UNITED STATES PATENT AND TRADEMARK OFFICE

APPLICATION NO.	FILING DATE	FIRST NAMED INVENTOR	ATTORNEY DOCKET NO.	CONFIRMATION NO.
10/712,770	11/12/2003	Ryoichi Nagayoshi	10873.1355US01	7405
53148 7590 06/27/2007 HAMRE, SCHUMANN, MUELLER & LARSON P.C. P.O. BOX 2902-0902 MINNEAPOLIS, MN 55402			EXAMINER DURNFORD GESZVAIN, DILLON	
			ART UNIT 2622	PAPER NUMBER
			MAIL DATE 06/27/2007	DELIVERY MODE PAPER

Office Action Summary	Application No. 10/712,770	Applicant(s) NAGAYOSHI ET AL.	
	Examiner Dillon Durnford-Geszvain	Art Unit 2622

DETAILED ACTION

Figure A

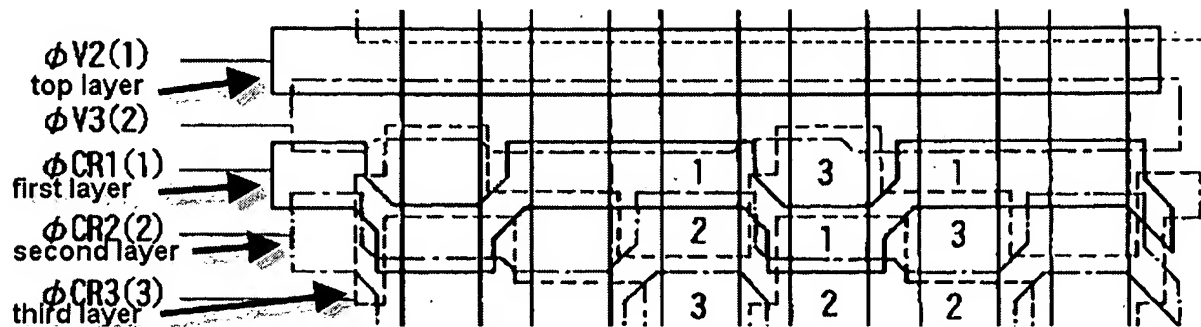
As to claim **25**, see the rejection of claim **1** and note that lizuka further teaches the solid state image sensing device according to claim **1**, wherein the vertical transfer parts have at least three layers of electrode films (see Fig. A below), and the transfer electrodes provided independently of those of vertical last stages of the other columns are formed of at least one of layers of electrode films that includes a top layer (see Fig. A below).
